ADDENDUM 1 – JOB 23910

TO: All prospective bidders on Projects TAC-1-981(138), Job No. 23910 scheduled for the February 7, 2025 bid opening.

PROJECT INFORMATION					
Project:	TAC-1-981(138)			PCN:	23910
Location:	Bismarck Parks and Recreation District, South Washington Street Trail				
Date:	2-3-2025	Lead Designer: Thomas Demke			
Bid Opening	Date: 2/7/2025	JOB#: 23910	Addendum#:	1

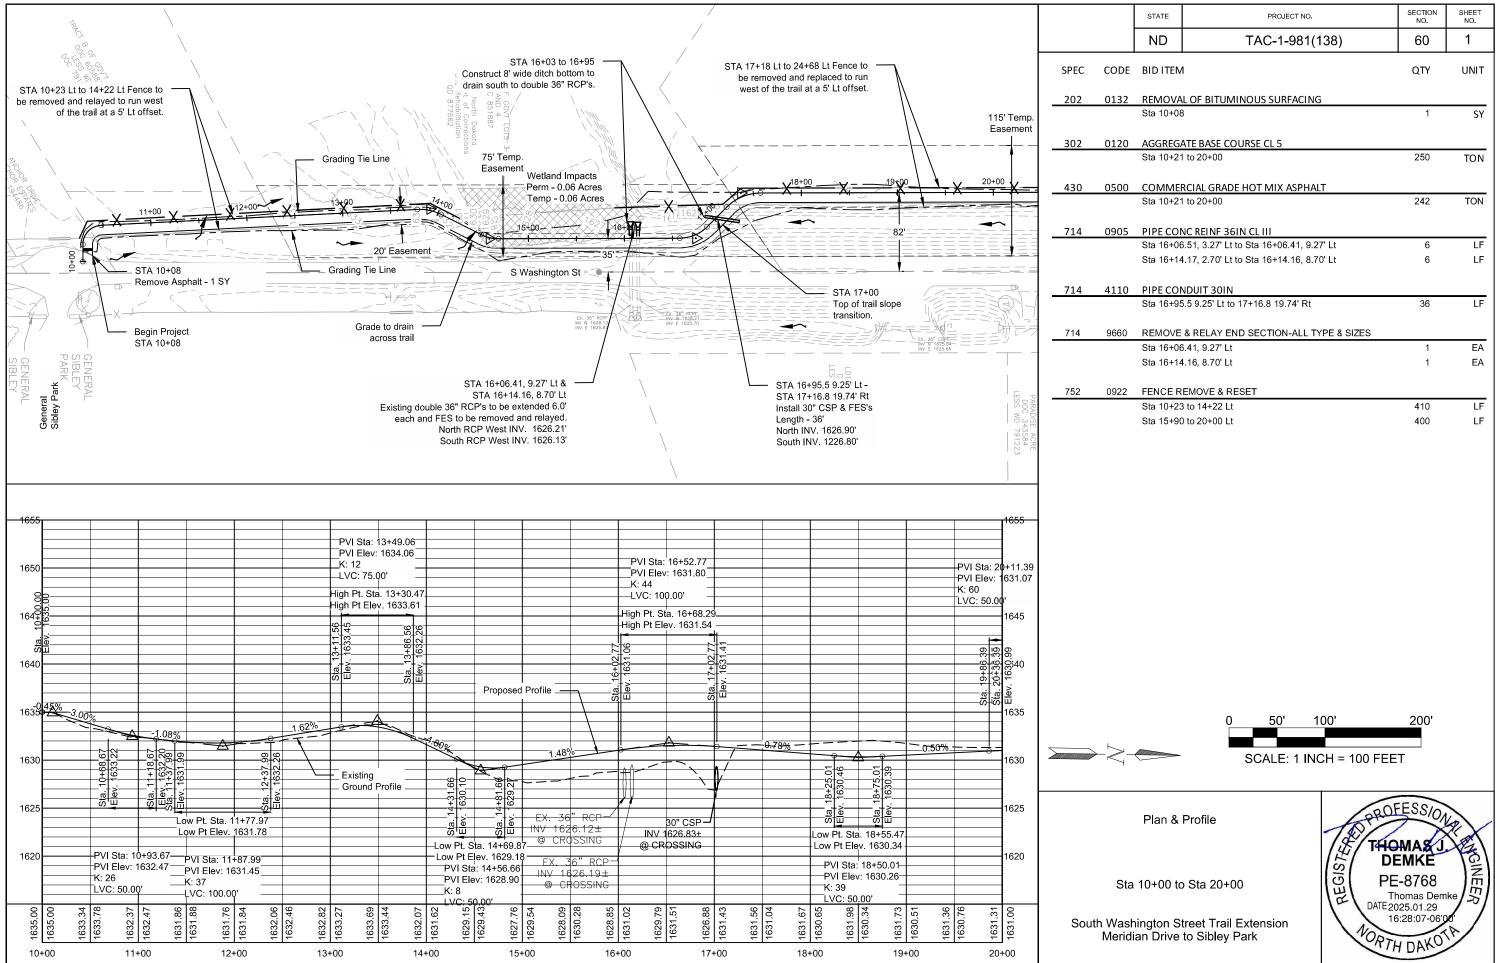
PLAN SHEET CHANGES					
Section Sheet Description						
6 1 Added Detectable Warning Panel note. 750-P02						
601-3Modified Temporary Easements from Stations 17+30 to 24+64, 27+65 to 2 33+07 to 36+23602-3Modified Permanent Easement from Station 29+62 to 32+27		Modified Temporary Easements from Stations 17+30 to 24+64, 27+65 to 29+62, and 33+07 to 36+23				
		Modified Permanent Easement from Station 29+62 to 32+27

- 750-P01 SIDEWALK CONCRETE 6IN: Include provide a clean tie in edge for Concre the unit price "Sidewalk Concrete 6IN"
- 750-P02 DETECTABLE WARNING PANELS: steel detectable warning panels. Colo 6.3.
